**RE: Industrial Water Engineering
Grading and Drainage Plan
Engineer's Stamp Date 9/12/17
Hydrology File: C16D006LL**

Based on the information provided in the submittal received on 9/14/17 the above-referenced submittal cannot be approved for Site Plan for Building Permit until the following are corrected:

DRAWING NAME
**GRADING &
DRAINAGE PLAN**
SHEET NO.
CG-101

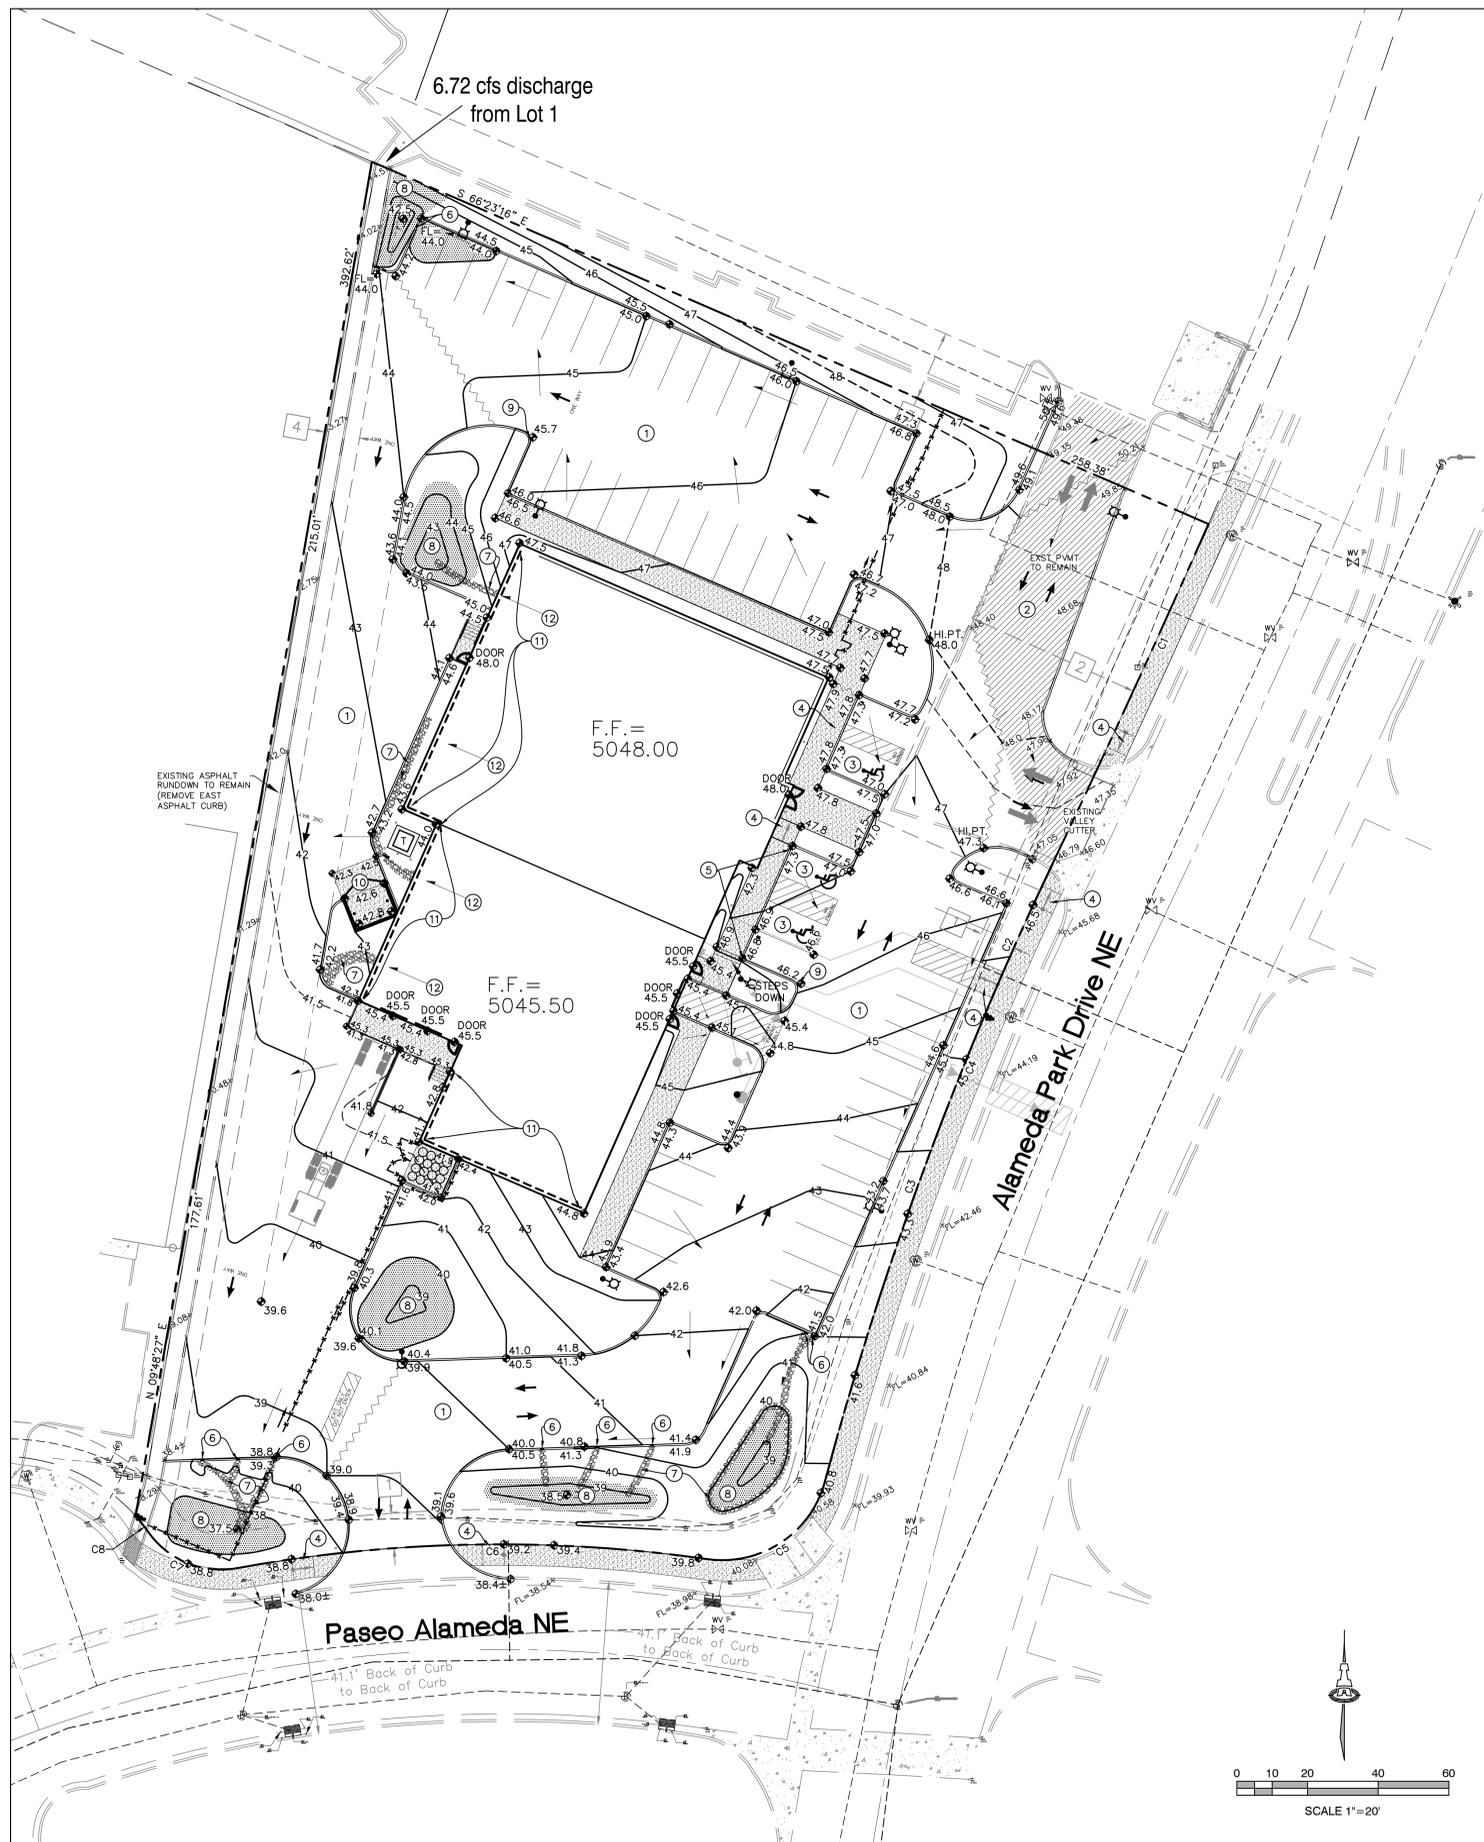
1. Correct text size on callouts to be 0.10" or larger; this applies mostly to the survey info for the water valves, drop inlets, and storm drain.
2. Call-out top of pond, bottom of pond, and volume on sheet CG-101.
3. Clarify the drainage rundown along the west side of the lots. If the Asphalt curb is removed, how will flows route to pond P5? If the intent is to convey new flows in the rundown, it will need to get routed through the pond before discharging to the street.
4. This project will require an ESC plan, submitted to the Storm Water Quality Engineer (Curtis Cherne, PE ccherne@cabq.gov, 924-3420).

DRAINAGE SUB-BASINS FOR FIRST FLUSH RETENTION

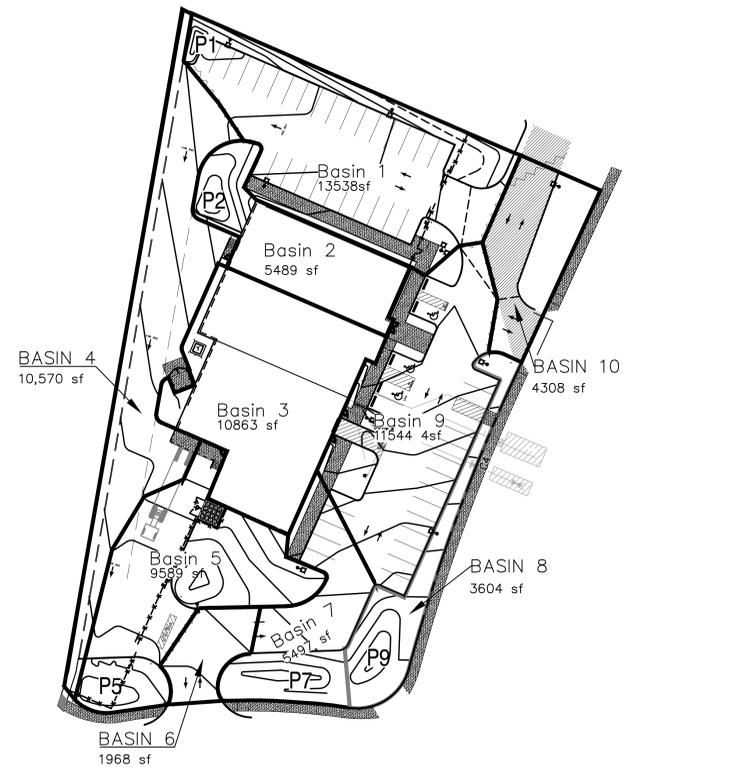
1. Label the plan as "Conceptual, Not For Construction." If this is intended as the building permit plan, then all building permit comments will need to be addressed prior to SPBP.
2. It is unclear what sub-basins drain to which ponds and if the ponds are large enough for their contributing drainage areas. Clearly show where each sub-basin drains to and what the required vs. provided first flush volume is at each pond.
3. Payment of cash-in-lieu for the first flush volume not captured is required [$\$8.00/CF \times (CF \text{ of bypass flows})$].
